MECKLENBURG COUNTY HEALTH DEPARTMENT

APPLICATION FOR PERCOLATION TEST

SUBJECT: APT #6620 (Ralph Squires Construction Co.)
Lot No. 17-D, Brigadier Lane
Jefferson Colony Subdivision
9-5-73

SITE DISAPPROVAL REPORT
INDIVIDUAL SEPTIC TANK SYSTEM WITH SUBSURFACE, SOIL ABSORPTION, EFFLUENT DISCHARGE

7) ACCURATELY DIAGRAM & DIMENSION LOT

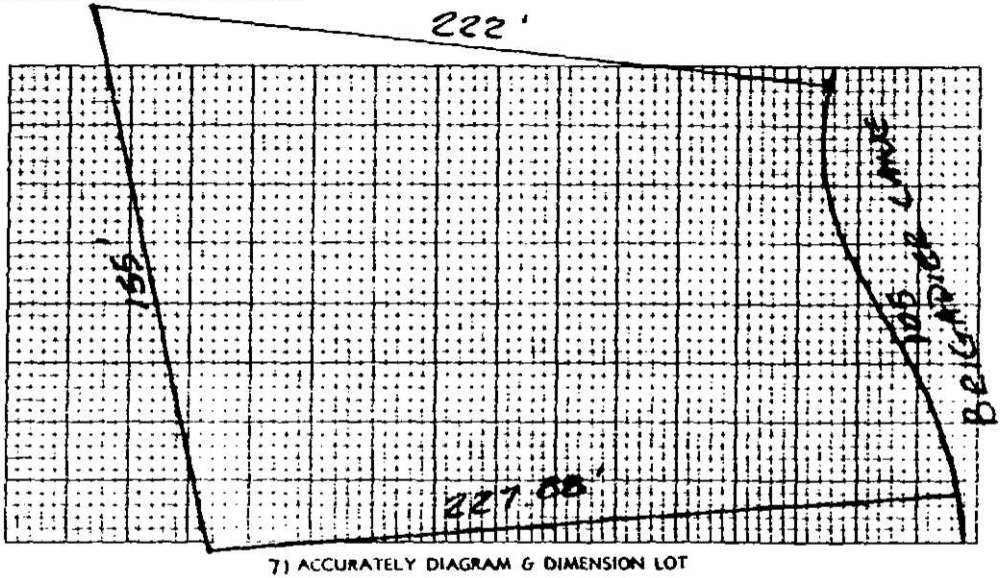
Soils were found to be of the Enon series. These soils have plastic and sticky clay subsoils which contain swelling clay minerals. These soil characteristics result in inadequately slow percolation rate and permeability.

Based on this investigation, it appears that the lot is unsuitable for installation of a septic tank system.
